ADDENDUM

PROJECT	Black Hawk County Courthouse Renovations	PROJECT #	23109
OWNER	Black Hawk County	DATE	January 19, 2024
LETTING DATE	January 29, 2024	ADDENDUM #	1

4 MEPT – see attachment with MODUS titleblock noted "Addendum #1".

SHEET NAME:
BASEMENT LOW
VOLTAGE PLAN

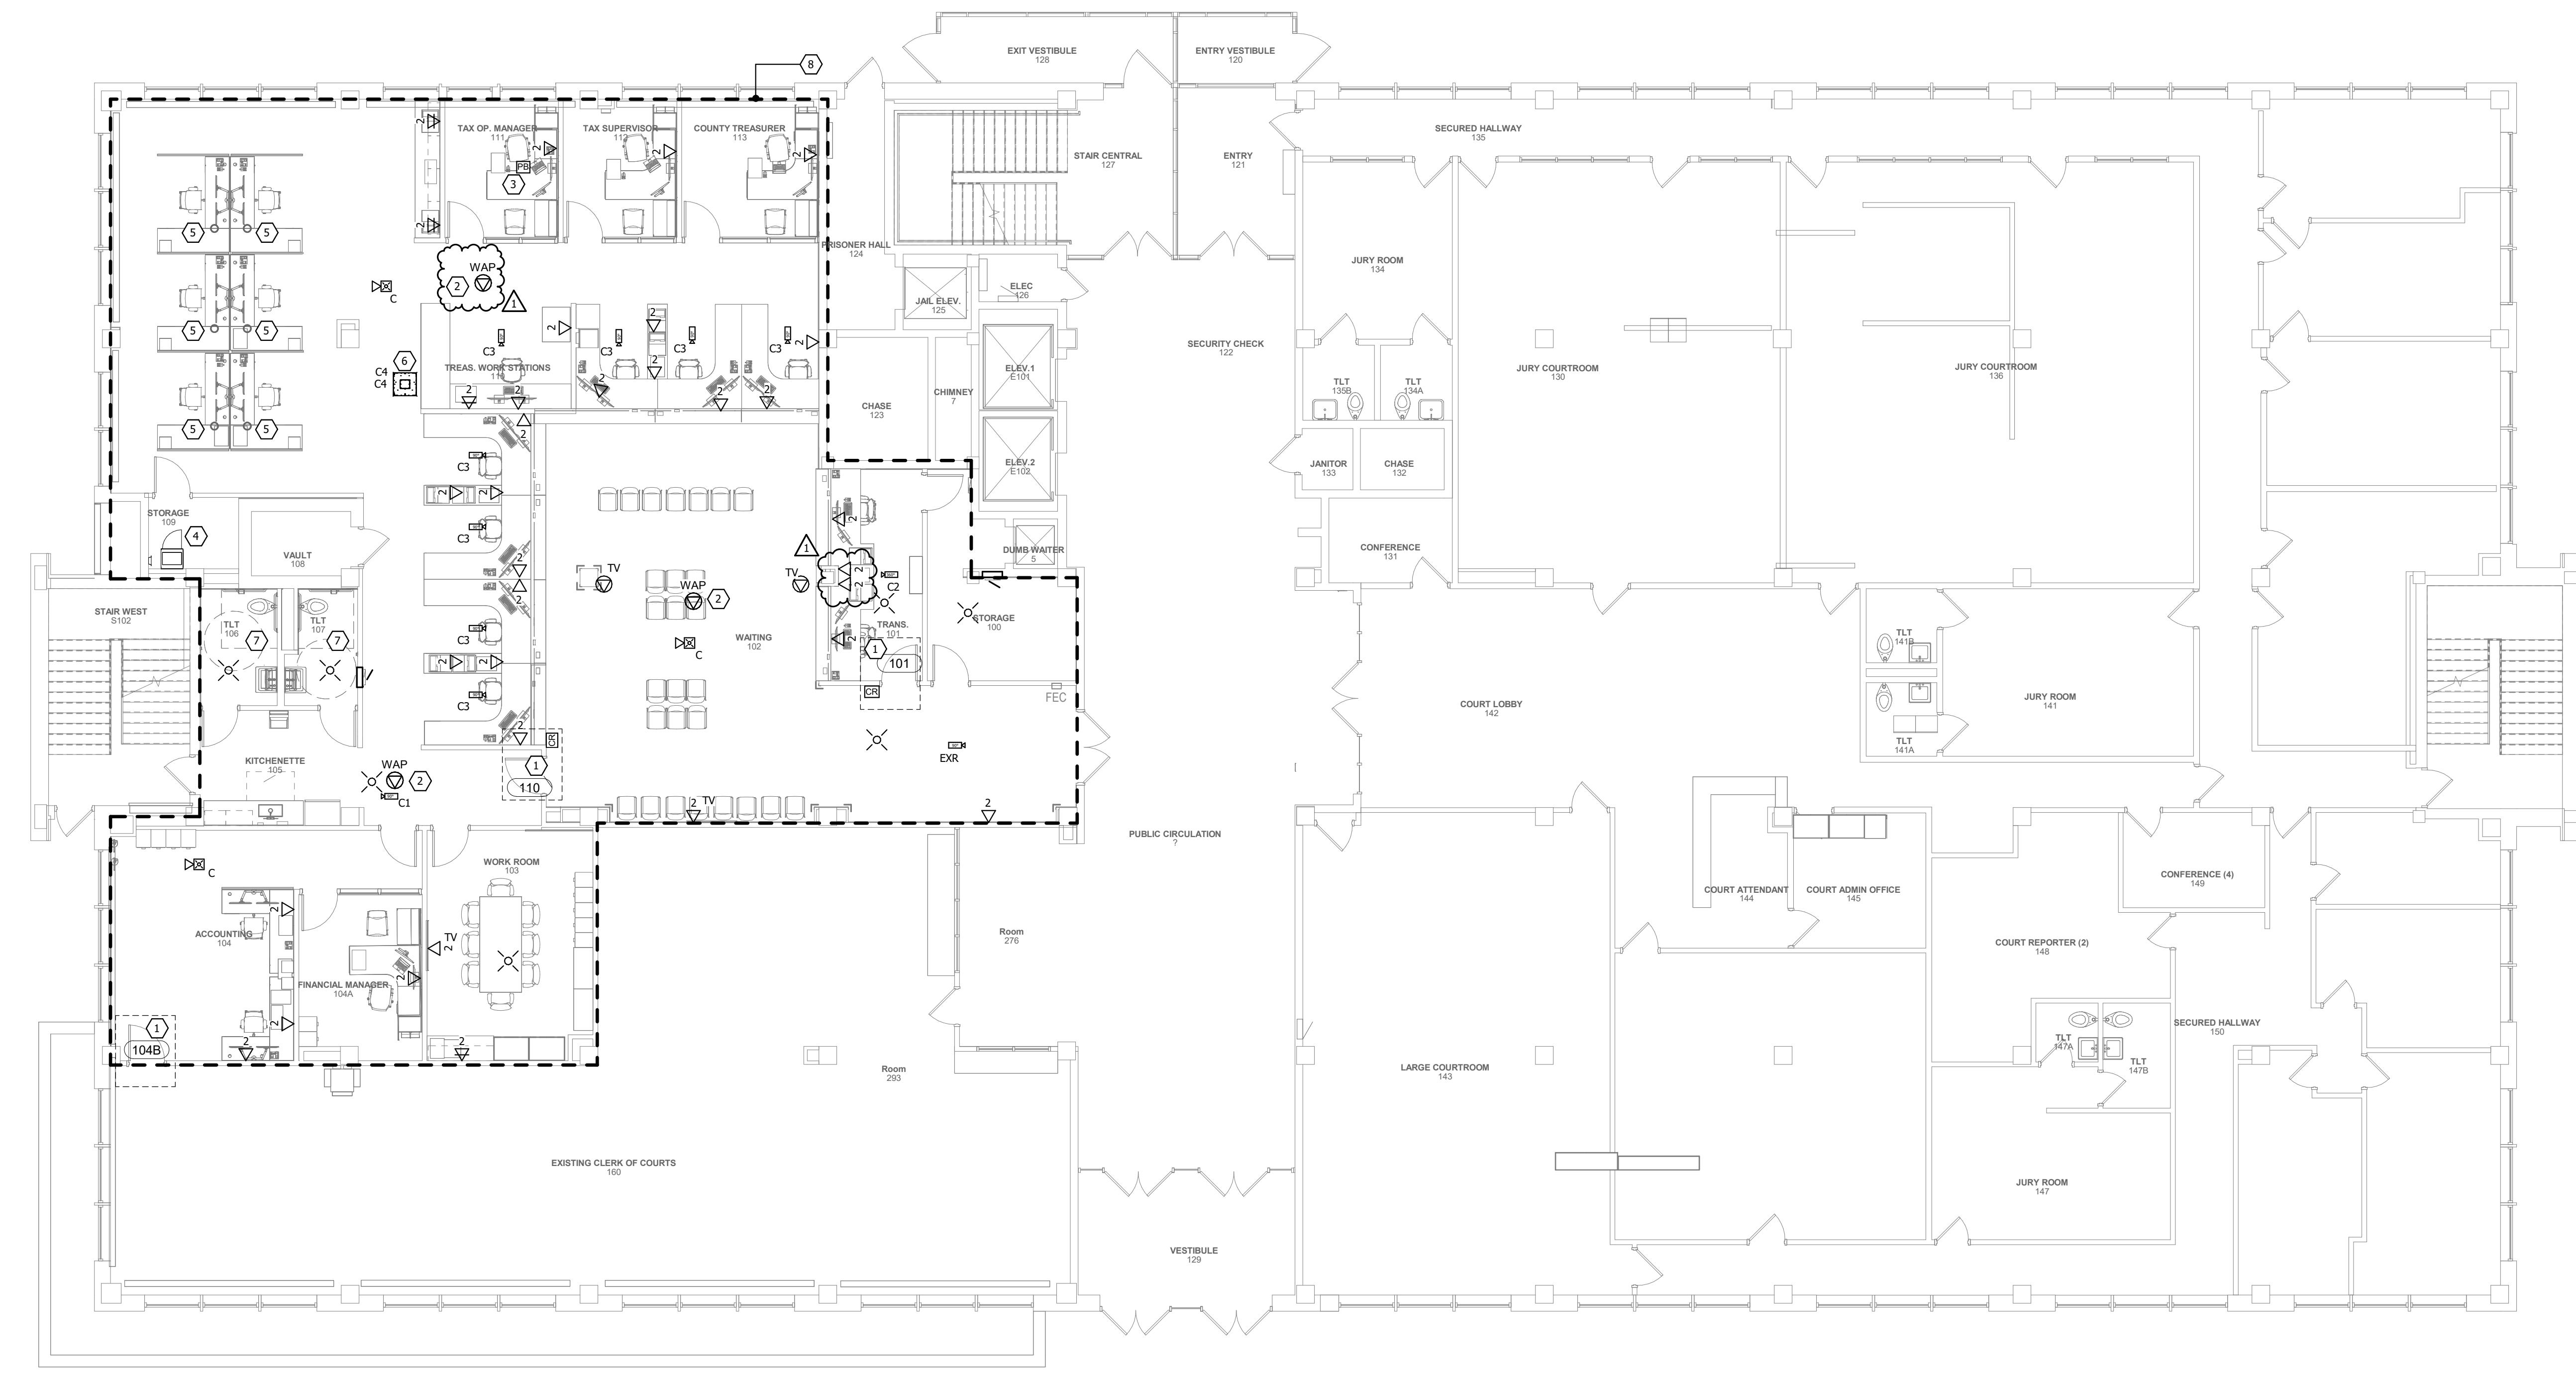
SHEET TI.01 | BASEMENT LOW VOLTAGE PLAN

1. **CLARIFY.** Fire Alarm work indicated on the drawings is for reference only. New fire alarm work is to be done by owner's fire alarm contractor as a separate project. Electrical contractor is responsible for protecting the existing devices only and coordinating with the owner's fire alarm contractor during the construction process.
2. Conference 080B
 - A. **ADD.** WAP location and reference note 2.
3. Circulation 026
 - A. **ADD.** WAP location and reference note 2.
4. Clerks of Courts Storage
 - A. **ADD.** Owner provided network panel.
5. Office Specialists 053
 - A. **ADD.** Owner provided rack, TGB, and reference note 4.
